Detailed Site Plan Departure from Design Standards Alternative Compliance Flats at Glenridge Station

DSP-23008
DDS-24002
AC-24005

SUBJECT: Detailed Site Plan DSP-23008
Departure from Design Standards DDS-24002
Alternative Compliance AC-24005
Type 2 Tree Conservation Plan TCP2-001-2025
Flats at Glenridge Station

Figure 1: Site Plan

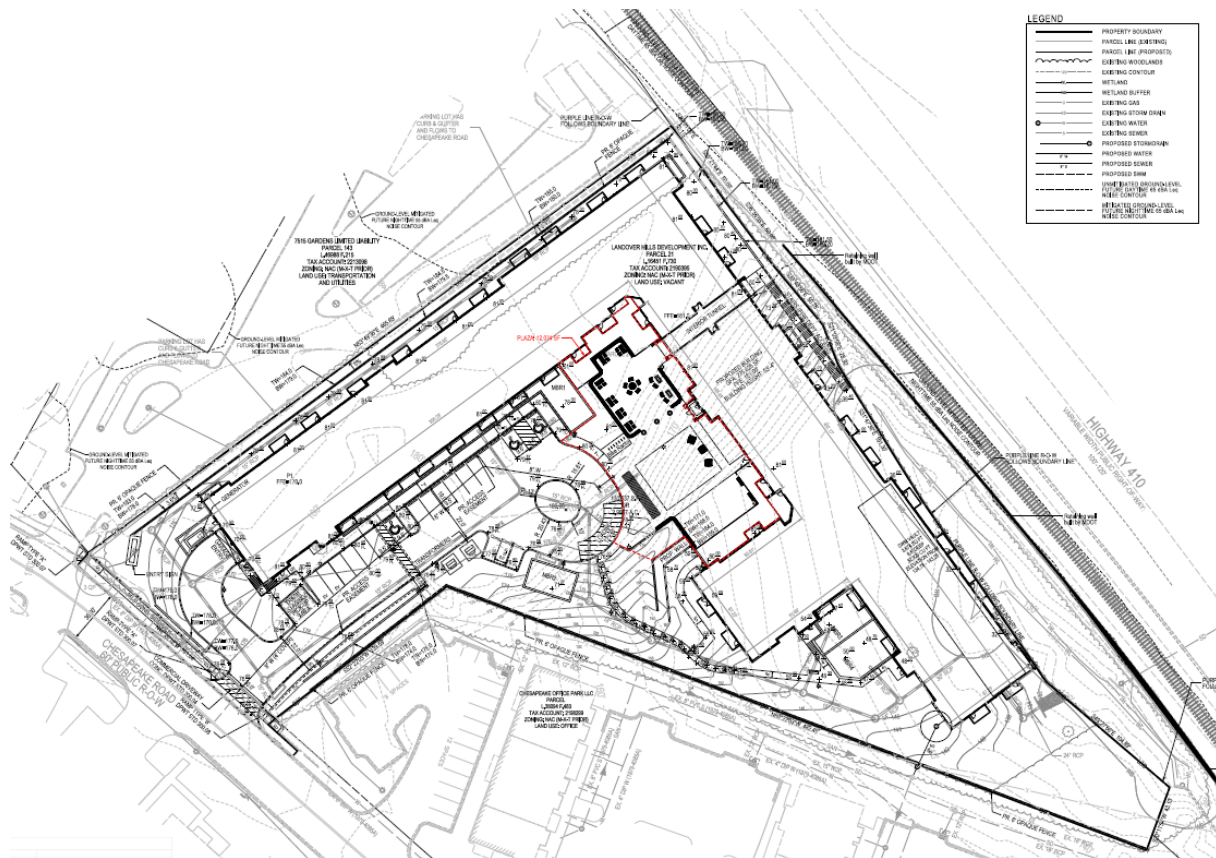
Notes: *Among 337 proposed parking spaces, 317 are located in the parking structure and 20 surface parking spaces are located in front of the proposed building. The floor plan for the parking structure, submitted with this DSP, does not include dimensions of drive aisles and parking spaces. A condition is included herein requiring the applicant to show all dimensions of drive aisles and parking spaces on the floor plan of the parking structure.

**The size of compact parking spaces, shown on the plan, is 8 feet by 16 feet. A condition is included herein requiring the applicant to correct the size of compact parking spaces to be 8 feet by 16.5 feet.

***Pursuant to Section 27-566 of the prior Zoning Ordinance, among 337 parking spaces provided, eight spaces need to be handicap-accessible. According to the Americans with Disabilities Act (ADA) requirements, among eight spaces, two need to be handicap van-accessible parking spaces. A condition is included herein requiring the applicant to indicate these two required handicap van-accessible parking spaces, with dimensions, on the plan and add this number to the parking schedule on the coversheet. In addition, the size of the handicap-accessible parking spaces, shown on the coversheet, is 9 feet by 18 feet, for which a condition is included herein requiring the applicant to correct it to be 9 feet by 19 feet.

Figure 5: Detailed Plan for Central Plaza

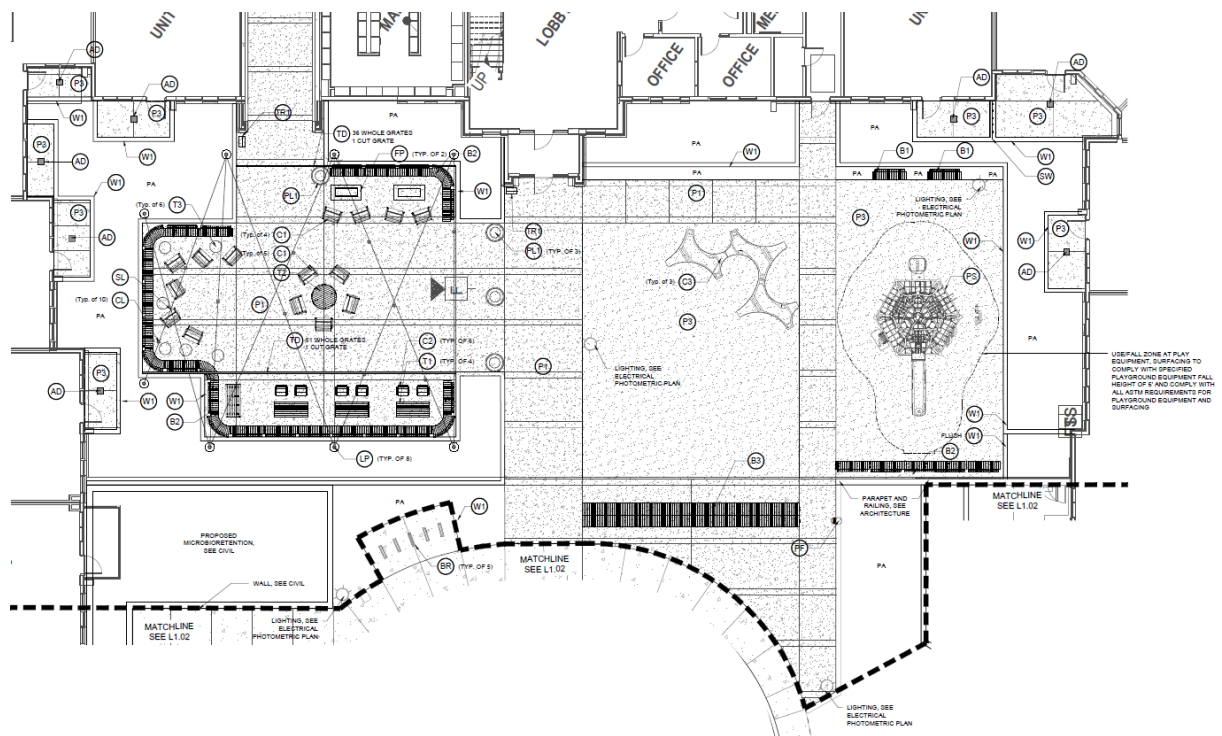
within the plaza. The surface of the plaza is designed with a variety of paving, such as scored concrete with/without integral colors, masonry, artificial turf for safety, and detectable warning pavers. Lighting is incorporated to provide for both safety and visual effect, especially during the evening. A public access easement will be expected to ensure its accessibility to the public, as shown on the submitted plan. With the provision of this plaza, this DSP receives an additional, approximately 0.74 FAR (or 96,592 square feet).

Utilizing the two optional methods as discussed above, the total FAR permitted for the subject DSP is approximately 2.14 (or 279,544 square feet). The total square footage of the development, proposed with this DSP, is 275,625 square feet (approximately 2.11 FAR), which is below the permitted FAR. The submitted site plan shows the boundary of the plaza for a public access easement, to ensure public access and use, but does not delineate the walkway area on the plan, to ensure the public can actually access the plaza. Conditions are included herein requiring the applicant to execute a public access easement or covenant at the time of final plat and delineate a public pedestrian easement for public access.

Figure 6: Relationship between Building, Purple Line and MD 410

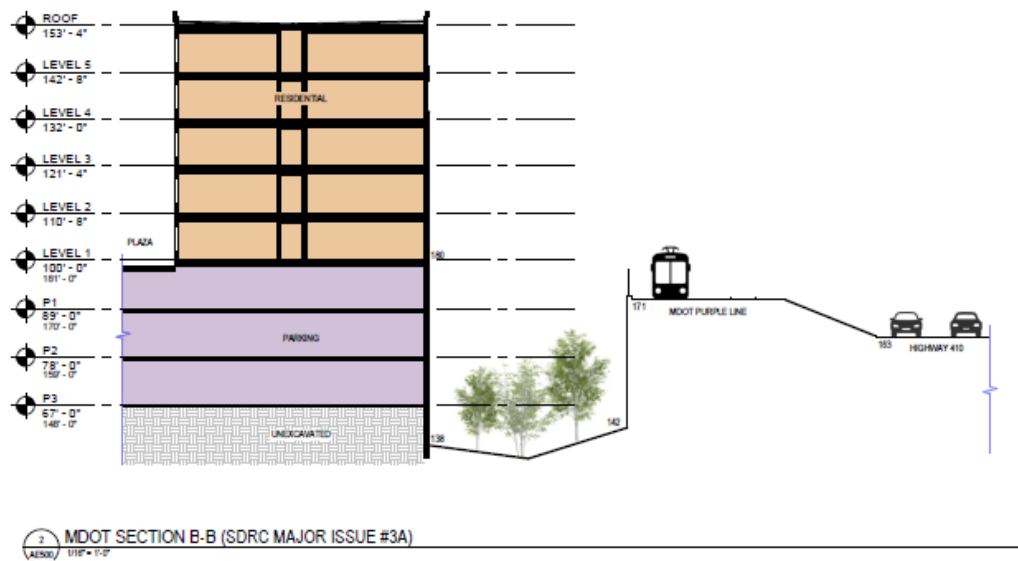
The required 50-foot-wide buffer, with plants, will likely be provided by the existing vegetation within the ROW of MD 410, which separates the proposed building from the Purple Line tracks. The subject DSP concentrates density in a mixed-use building on a property near a transit station. This approach will not overcrowd the land and, instead, leave some area for open space to bring light and air to the property. In particular, the applicant proposes open space in the form of a plaza in front of the building.

The building cannot be moved away from MD 410 without shrinking the proposed central open space and creating a more disjointed open space system. Therefore, based on the property's shape and topography, to achieve the desirable density of this project and provide meaningful open space, a departure from the 50-foot-wide buffer is necessary.

Based on the analysis above, staff support Departure from Design Standards DDS-24002, for a departure to allow approximately 0.5 feet from the eastern property boundary along MD 410 and no plant materials, as a result of the unique shape of the property, along with the steep slope and retaining wall separating the property from the Purple Line tracks. As noted in the beginning of this finding and discussed in Finding 12 below, the applicant filed Alternative Compliance AC-24005 from the requirements of Section 4.6 of the Landscape Manual. The Planning Director denied this request because there is no feasible proposal that would exhibit equally effective design characteristics, as defined in the Landscape Manual.
